City of Pleasanton

Housing Site Development Standards and Design Guidelines

DRAFT

Diagram E

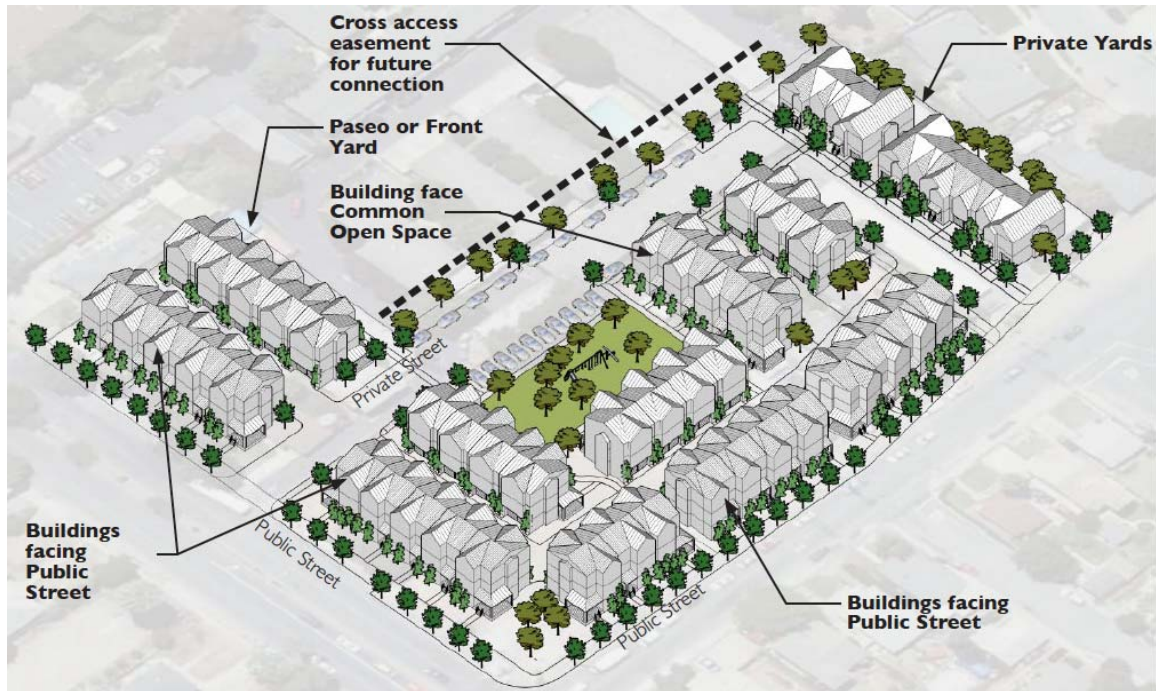
- 4) Page 16, Design Guidelines, Diagram E, Medium and Large Sites, 3rd Bullet Point, “Internal Sites Provide Through Access” (also see 16.a below)
Comment: We have designed an optimal multi-use, highly dynamic site concept that will creatively link residential, retail and office uses on this corporate campus property, creating a cohesive “community” to be enjoyed by all individuals who work, live, visit and shop there. We understand the primary purpose of the statement is to guide optimal site design for emergency vehicle and general circulation. Our site is located within an existing parking lot used by office tenants and, therefore, we have designed for optimal and efficient vehicular and pedestrian circulation for the three prescribed uses (existing office, residential, and retail). Our site design allows for both visual and physical vehicle and pedestrian connections – resulting in a walkable, bikeable and vehicular friendly community. Our concept accommodates through access for vehicles into the adjacent office, providing for multiple access routes to adjacent public streets. Our site cannot accommodate through access from one Public Street to a perpendicular Public Street without causing adverse impacts to the pedestrian linkages and associated green spaces between the various uses on the property. The pedestrian and green linkages on site are the true connective tissue for the larger

A3. Public Streets

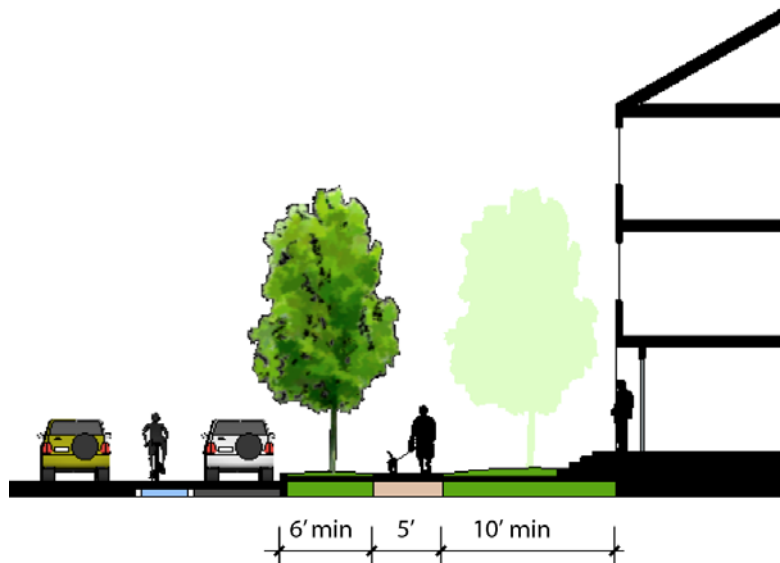
- 5) Page 18, Development Standards, A3.2: “Front setbacks should be a minimum 10 feet from back of sidewalk providing enough room for planting and privacy while still allowing a strong relationship between the units and the street”.

Comment: We have planned for a rich, highly visible, accessible retail plaza at the Owens Drive and Rosewood Drive intersection, for use by all retail patrons including on and offsite residential and office tenants, and the general public. To create a generous, visible, vibrant, pedestrian-friendly and accessible retail plaza, that effectively relates to our planned retail buildings, including storefronts, openings, and outside seating, we need some flexibility with retail building setbacks. We, therefore, request the existing setback from back of sidewalk be reduced from 10 feet to 5 feet for retail uses.

- 6) Page 18, Development Standards, A3.4: “Street trees shall be planted at least every 25-35 feet on average depending on tree species, not to exceed 40 feet.”

Comment: For multiple reasons, including those mentioned within item 5) above, it is very important that the retail buildings, signage, and outdoor seating areas be highly visible to ensure a vibrant and successful mix of retailers/tenants. We, therefore, request adding “with exception of retail adjacent to a Public Street” to the beginning of the sentence.

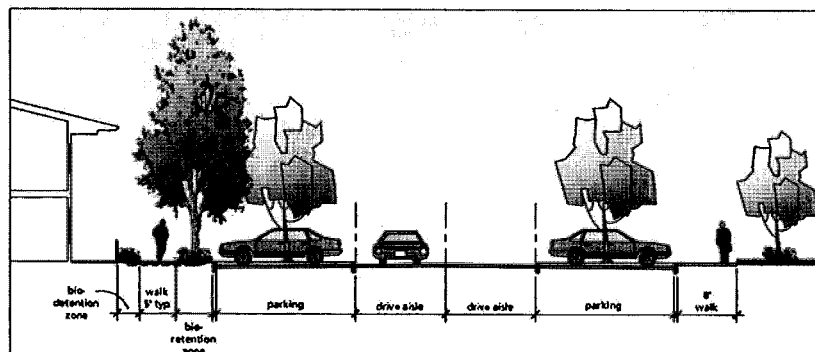
2. Design Guideline A1.b - Alleys and parking areas should not be used for primary circulation to the building entries and through the site. Primary entries should not orient to alleys or parking areas.

Design Guideline A2.b - Building fronts should include porches and door entries facing streets and open spaces.

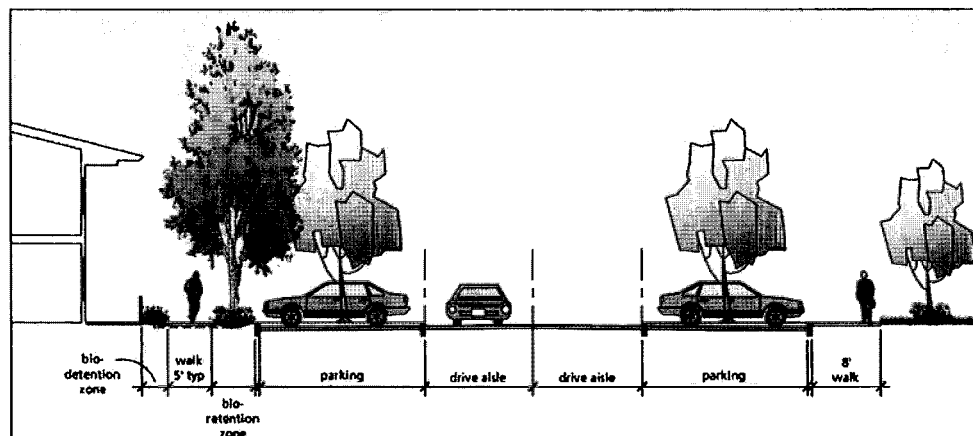
In order to achieve the City's desired density goals on these rezoned infill sites, there will be instances when home entries need to be aligned along alleys and or parking zones.

Carriage homes above ground floor garages are a building type that can be used to achieve desired densities while offering a variety of residential unit configurations and types that are desirable to the market place.

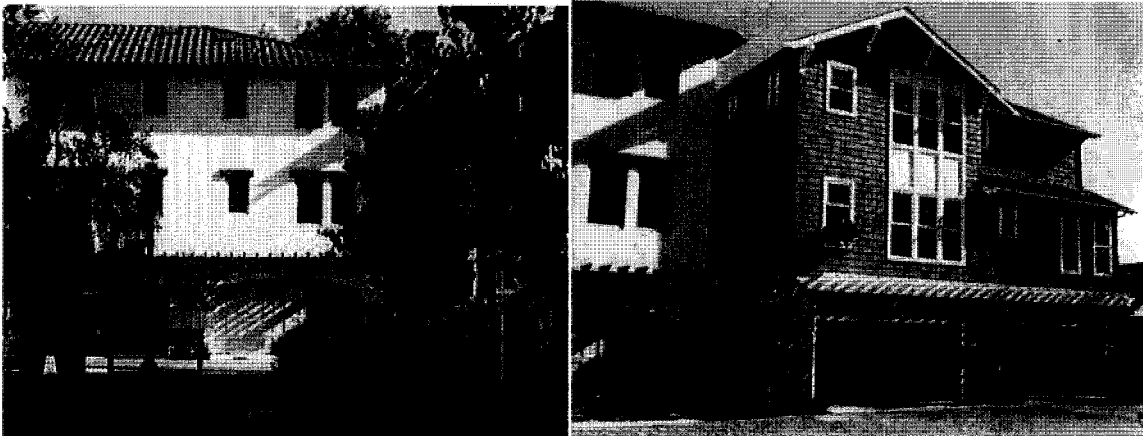
Specifying a 2 foot minimum recessed depth for garage doors creates the condition where the garage must be effectively 2 feet deeper to accommodate the recess, which may impact the ability to meet the 30 DUA density. A strong architectural presence can be achieved by recessing garage doors from the building façade less than 2 feet, providing architectural elements that protrude from the building facade, or additional architectural detailing. The building height also impacts the elevation. Examples of how an interesting elevation can be achieved without recessing the garage door a full two feet are shown below.

Design Guideline A5 - Garage doors should be recessed from building façades or architectural elements should be incorporated into the elevation.
